OLYMPIC DAM PROJECT

**Supplement to the Draft
Environmental Impact Statement**

APRIL 1983

Figure 6.8
GRABEN PALAEOGEOLOGY

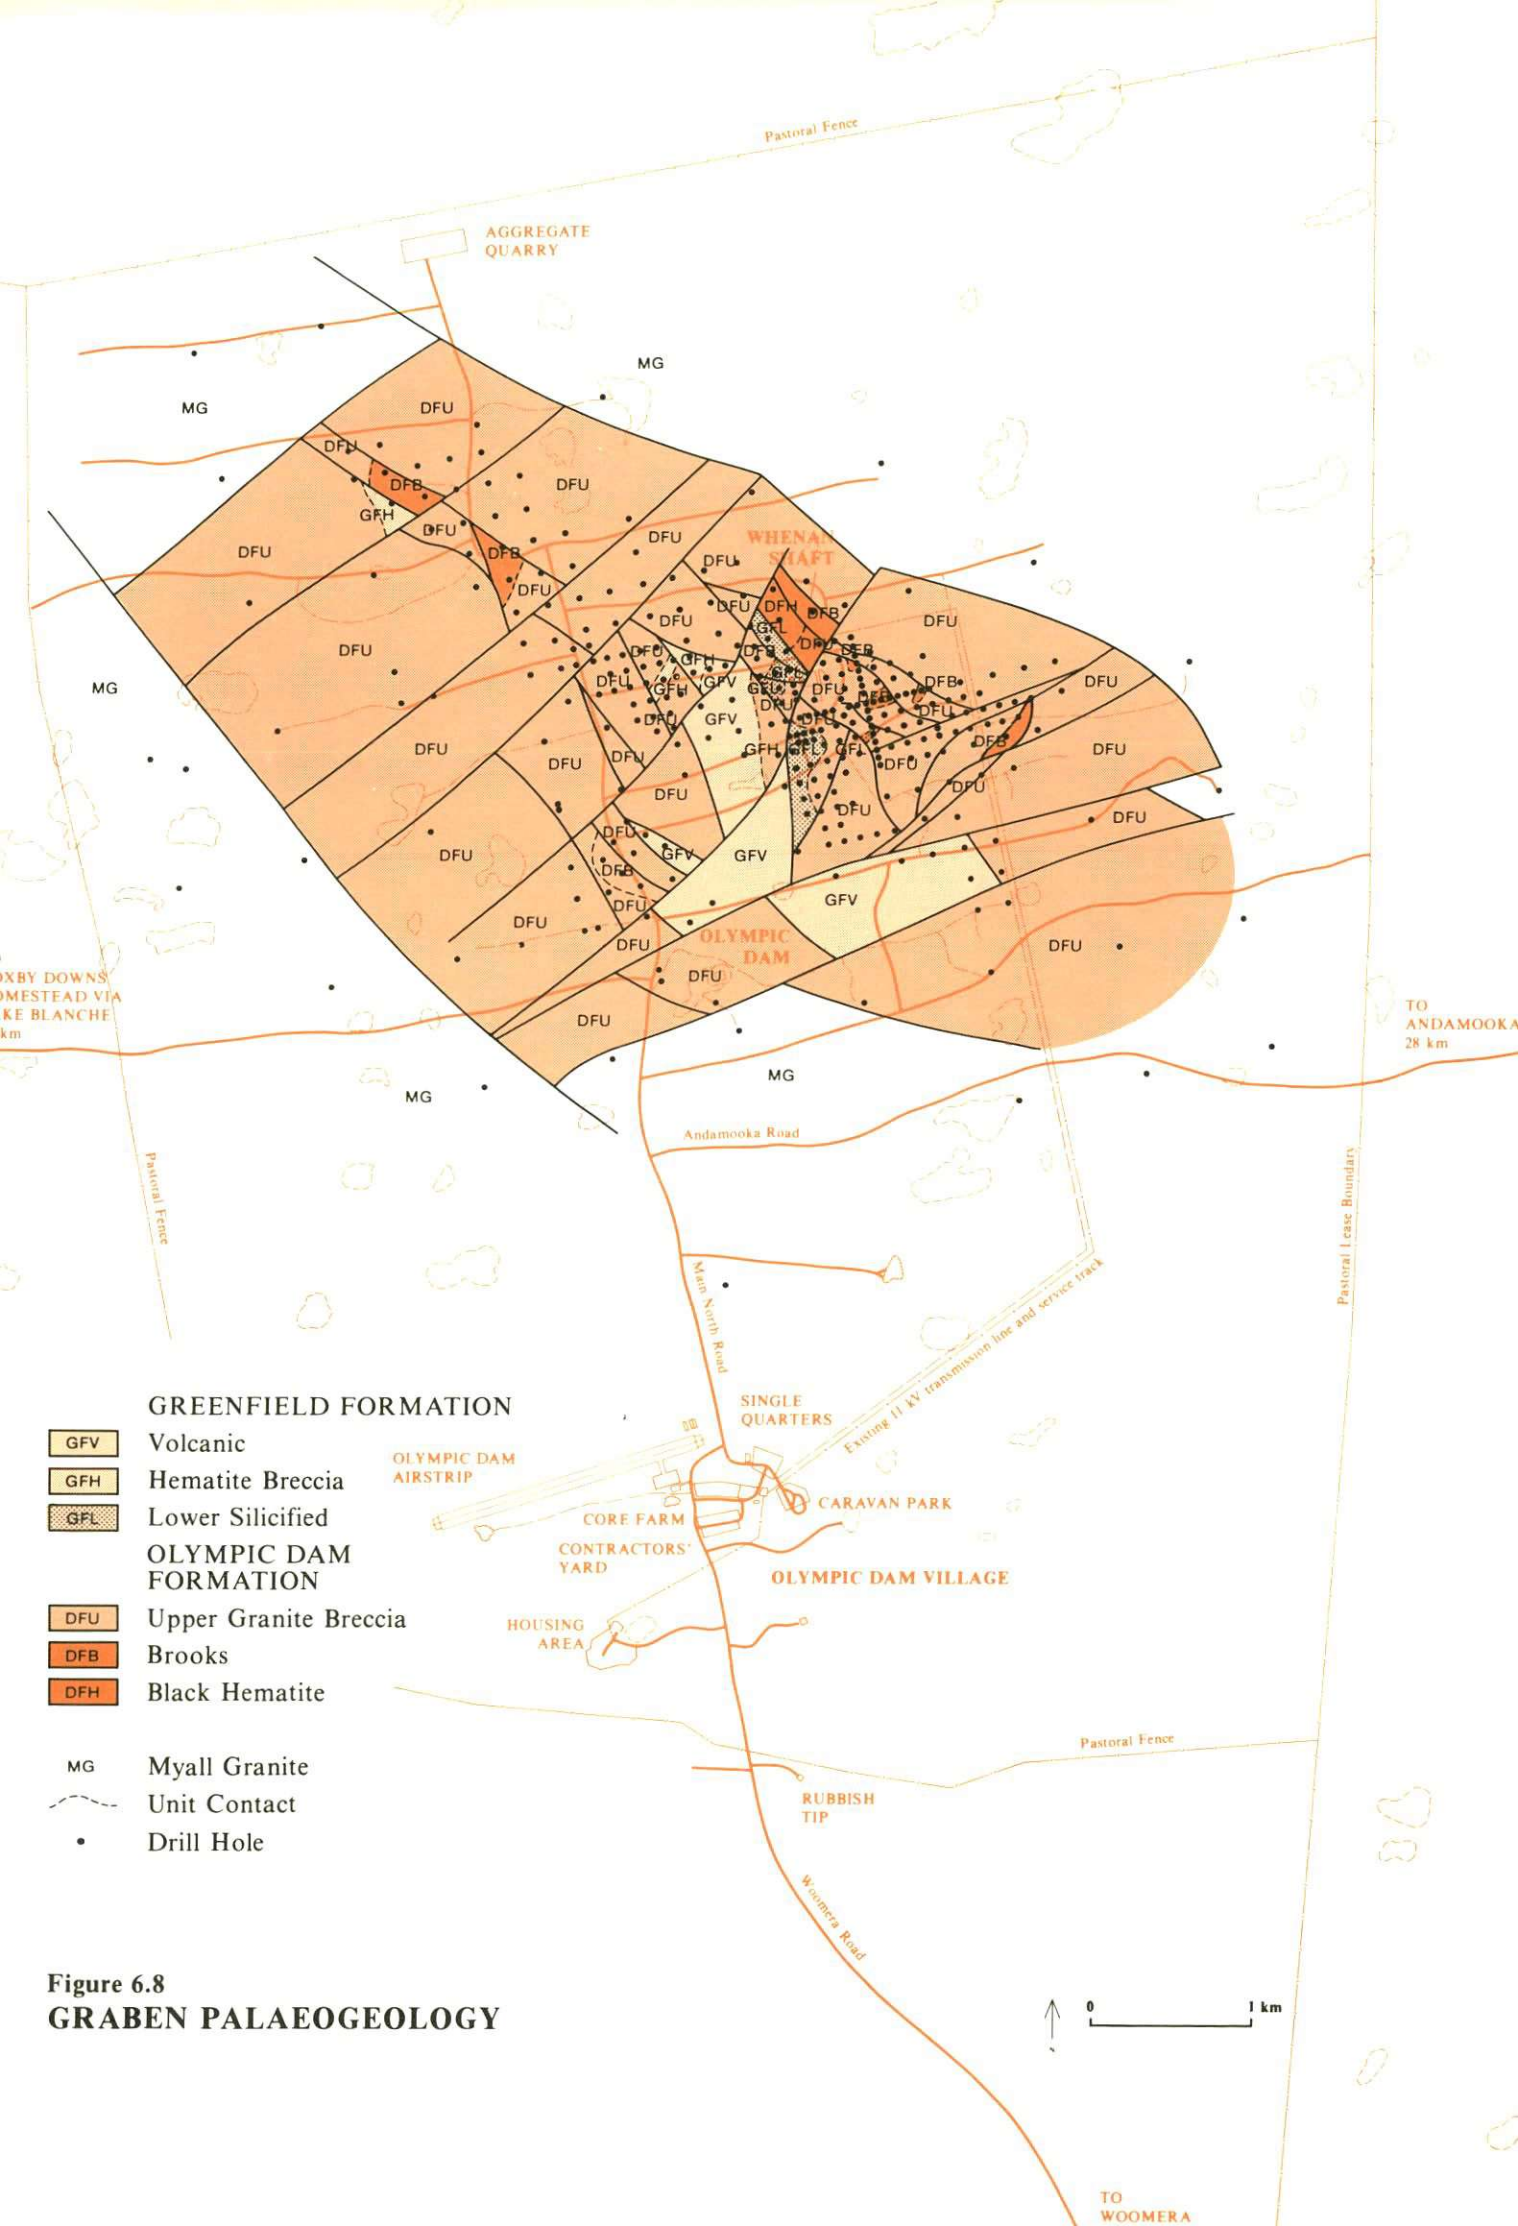
- Page 6.13 Figure 6.8
Colour coding of geological units was incorrect in a few instances.
See revised Figure 6.8.
- Page 7.11 Table 7.2 under 'Solids' column
Radium 226 content listed as '4.5 - 6.0 Bq/L'
should read
'4.5 - 6.0 Bq/g'.
